Item ID: D350-607-545 Accept *N900040100* Setup Start *NS1*
 Revision ID: Stop *NS2*
 Item Name: AS350/AS355 Quick Release Heli-Utility-Basket™, Short, Heavy Duty Lid
 Start Date: 5/4/2017 Start Qty: 1.00 *1* Cust Item ID:
 Required Date: 5/12/2017 Req'd Qty: 1.00 *1* Customer:
 Reference: SCHEDULED/C

DART SERVICE INSTRUCTION

**TO AMEND INSTALLATION INSTRUCTIONS D350-607-3 Rev.D,
INSTALLATION INSTRUCTIONS D350-607-4 Rev. C AND
INSTRUCTIONS FOR CONTINUED AIRWORTHINESS ICA-D350-607 REV.6**

A	NEW ISSUE	AJS	14.05.16
REV.	DESCRIPTION	BY	DATE
DESIGN	AJS	DART AEROSPACE LTD HAWKESBURY, ONTARIO, CANADA	
DRAWN	AJS		
CHECKED	<i>[Signature]</i>	DRAWING NO.	REV. A
MFG. APPR.	N/A	DSI 9699	SHEET 1 OF 2
APPROVED	<i>[Signature]</i>	TITLE	SCALE
DE APPR.	<i>[Signature]</i>	LUG REPLACEMENT	NTS
DATE	14.05.16	COPYRIGHT © 2014 BY DART AEROSPACE LTD THIS DOCUMENT IS PRIVATE AND CONFIDENTIAL AND IS SUPPLIED ON THE EXPRESS CONDITION THAT IT IS NOT TO BE USED FOR ANY PURPOSE OR COPIED OR COMMUNICATED TO ANY OTHER PERSON WITHOUT WRITTEN PERMISSION FROM DART AEROSPACE LTD.

FIGURE 1: INSTALLATION OF D4775-041 FWD STRUT

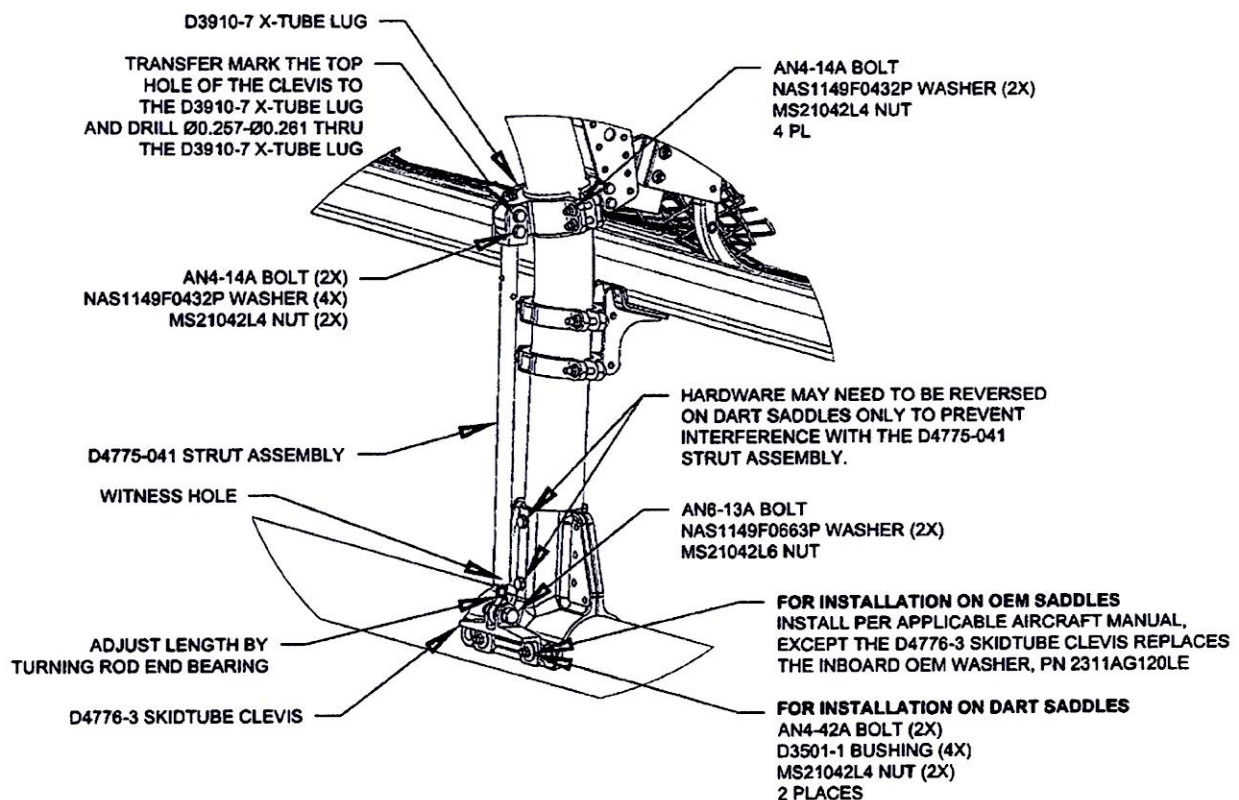
Modify the quantities for D3910-5 and add D3910-7 as follows:

3.1 Substitute the Forward Lower D3910-5 X-Tube Lug with the D3910-7 X-Tube Lug as shown in Figure 1.

3.2 Install the forward D4775-041 Strut Assembly. Transfer mark from the upper hole on the clevis of the D4775-041 Strut Assembly to the D3910-7 X-tube Lug and drill thru the lug $\varnothing 0.257$ - $\varnothing 0.261$ as shown in Figure 1. Touch up chemical conversion coating per MIL-DTL-5541. Check the witness holes located at the bottom end of the D4775-041 Strut Assemblies to ensure that the thread from the rod end extends past the witness hole.
Torque MS21042L4/-4 nuts to 50-70 in-lbs (5.7-7.9 N-m). Torque MS21042L6/-6 nuts to 160-190 in-lbs (18.1-21.5 N-m).
